## **CABINET MEMBER FOR ENVIRONMENT - 13 OCTOBER 2016**

### **PROPOSED TRAFFIC CALMING AMENDMENTS – WOODSTOCK ROAD, STONESFIELD**

**Report by Acting Director for Environment & Economy (Commercial)**

DRAWING TITLE  
**Section 278 Works**

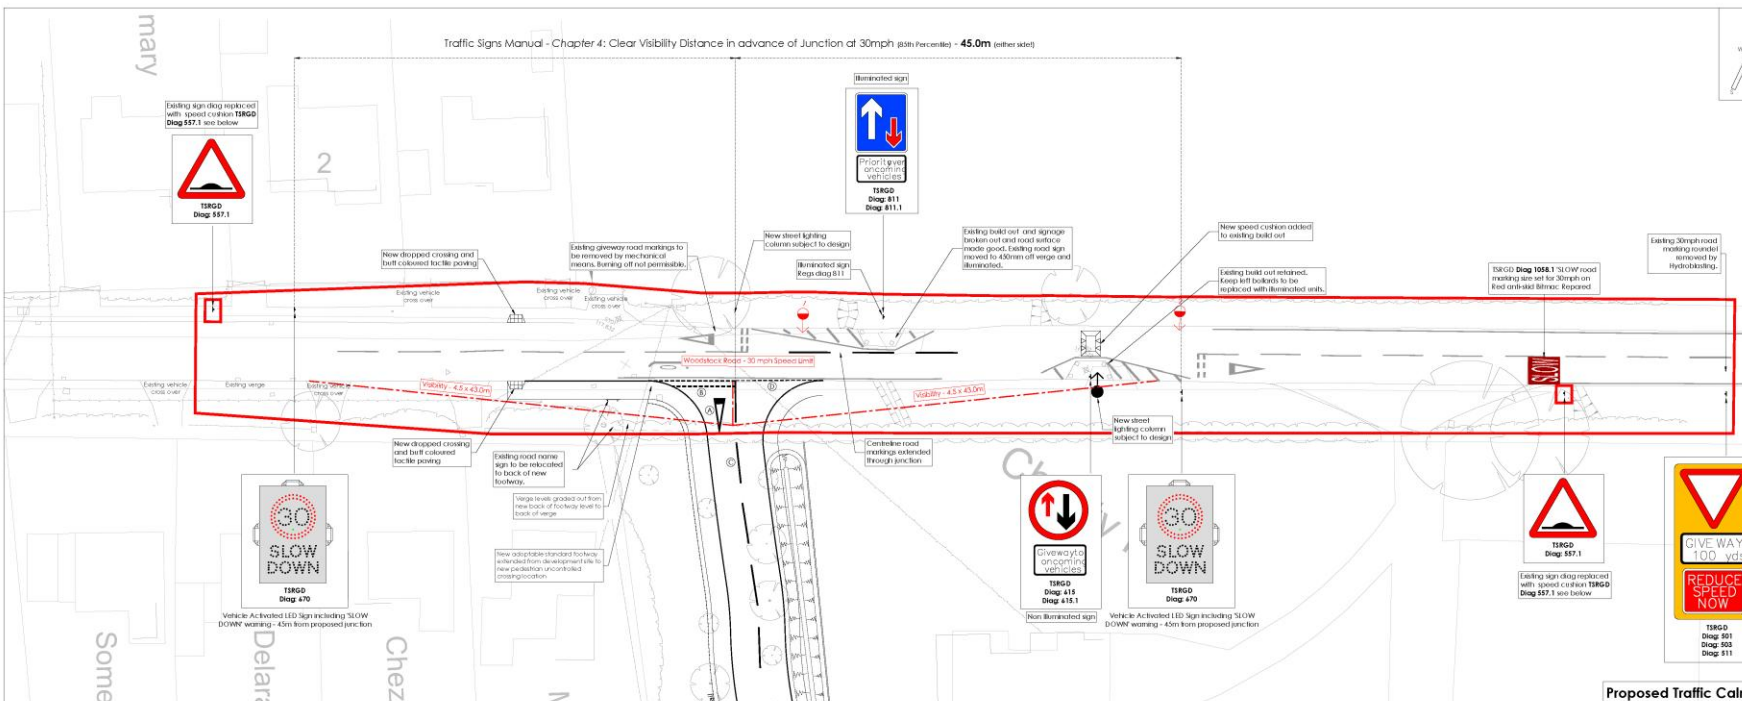
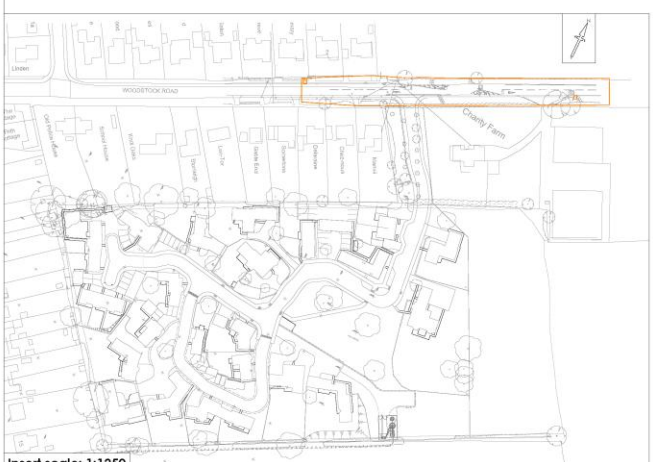
RESPONDENT	SUMMARISED COMMENTS
(1) Thames Valley Police	No objection.
(2) Local County Councillor	No comments received.
(3) Parish Council	<p>Objects – with the following comments:</p> <ul style="list-style-type: none"><li>▪ Councillors favoured a full width road hump with associated narrowing of the road and also wanted a VAS system in place.</li><li>▪ The preferred location was as far north as practical bearing in mind the undulations of the road. We asked for it to be moved so that it was not outside a resident's house and because it was felt further north would be safer.</li><li>▪ We also requested that a pavement be introduced on the same side of the road as the new build.</li><li>▪ Councillors discussed and agreed this with the developer before submission and note that the plan being consulted on is not the one they were led to believe would be submitted.</li></ul>

(6) Resident, (Woodstock Road, Stonesfield)	<p>Objects – with the following comments:</p> <ul style="list-style-type: none"> <li>▪ Single cushion is not sufficient to slow down traffic as vehicle tyres can go either side, whilst most will simply brake just before and then accelerate after it.</li> <li>▪ Current chicane is no deterrent and it doesn't slow down motorbikes and lorry drivers, additional traffic calming is required along the length of Woodstock Road.</li> <li>▪ Suitable alternative would be a mini roundabout by the entrance to the new development or at the junction with Greenfield Road.</li> <li>▪ Also narrowing of the road could be an option with only one car able to pass at the time.</li> </ul>

(7) Resident (Brook Lane, Witney)	<p>Objects – with the following comments:</p> <ul style="list-style-type: none"> <li>▪ The new access to the Development should never have been approved.</li> <li>▪ The access could be moved 11 metres to the west towards Stonesfield to be further away from the existing traffic calming chicane.</li> <li>▪ The traffic calming obstruction on the Northern side of the road could be moved to the east towards Woodstock. This would replicate the existing chicane but slightly further towards Woodstock.</li> <li>▪ The proposal will not create traffic calming and therefore should not be considered as a safe calming measure.</li> <li>▪ Any works to maintain safety traffic calming measures should be paid for by the developer.</li> </ul>

<p>(11) Resident, (Cockshoot Close, Witney)</p>	<p>Objects – with the following comments::</p> <ul style="list-style-type: none"> <li>▪ The priorities for traffic turning right out of the new housing development are dangerously confusing. While traffic turning right has to give way to traffic passing on the main road, once it has pulled across it then has priority over traffic approaching from the right.</li> </ul>

<ul style="list-style-type: none"> <li>▪ This could cause confusion, and could result in a potentially dangerous collision, or at least an embarrassing confrontation in the middle of the zone between the speed cushions, if the vehicle driving towards the village was unable to stop after first noticing the vehicle turning right out of the development.</li> <li>▪ This scenario is made more likely by the sightlines, as a driver turning right out of the development might not see a vehicle approaching from Woodstock at some speed, before it is too late.</li> <li>▪ I would not like to be a resident of this new housing area having to turn right towards Woodstock on a regular basis.</li> </ul>

(13) Resident, (Woodstock Road, Stonesfield)	<p>Objects – with the following comments::</p> <ul style="list-style-type: none"> <li>▪ Welcomes the VAS, but feel the overall proposals are unsatisfactory.</li> <li>▪ Feels that removing the existing traffic calming feature will seriously reduce the deterrent to speeding motorists.</li> <li>▪ Believes that a full width speed hump would be more effective than the cushion arrangement that is being proposed (although understands this may affect emergency vehicles).</li> <li>▪ An extra traffic calming feature on the southern side of the new access is necessary, in order to negate speeding of vehicles on the exit of the village.</li> <li>▪ Would like to see some form of 'village gateway' feature installed as part of the scheme to provide additional calming.</li> </ul>

16. The concerns in relation to the siting of the build out in relation to the new access are noted, but the positioning of vehicles passing through the calming feature should not lead to conflict, with traffic travelling towards Woodstock remaining on the north side of the road, and traffic heading into the village – while it will have moved to the offside to pass through the build out – will then be return to the nearside ahead of the access.

22. The specific request in the petition for the consideration of a full width road hump is noted, and it is accepted that this would very likely provide a stronger control of speeds as compared to the speed cushion currently proposed. The choice of a speed cushion in the current proposal reflected the fact that features of this type are quite widely used in the county. They appear to be effective in moderating speeds, but also avoid some of the potential issues associated with full width humps for vehicles such as ambulances and buses.

23. It should be noted that in addition to the speed cushion, the current proposals also include the provision of two vehicle activated signs to help moderate speeds and the provision of a short length of footway on the southern verge and dropped kerbs to link to the existing footway on the opposite side.
